SERVICE BULLETIN # 00004

SUBJECT: Installation of Coca-Cola Lock Cover (Old Style)

MODELS: All Coca-Cola and Cold Drink Venders P.O. #1172 and before.

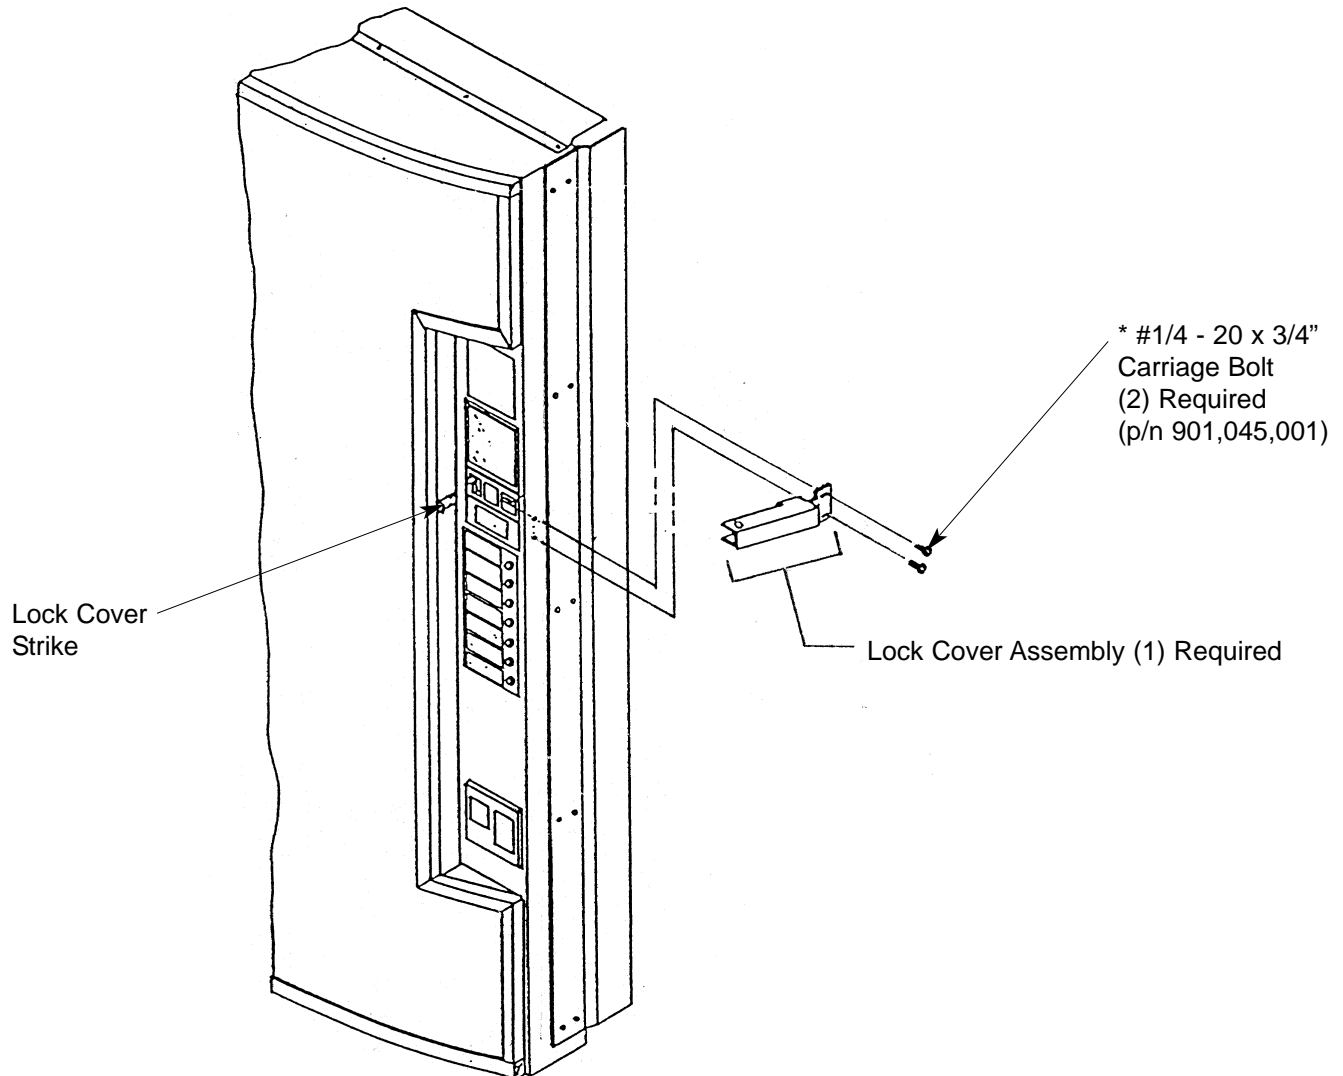
1. When installing Lock Cover Assembly and Lock Cover Strike, remove all four washers.
2. Nuts and bolts were installed onto machines as of production run #1012.
3. Replace the (2) identified 1/4" - 20 Carriage bolts (see "**") that were supplied stock with vender with the bolts supplied with this kit. However, use the stock Keps nuts.
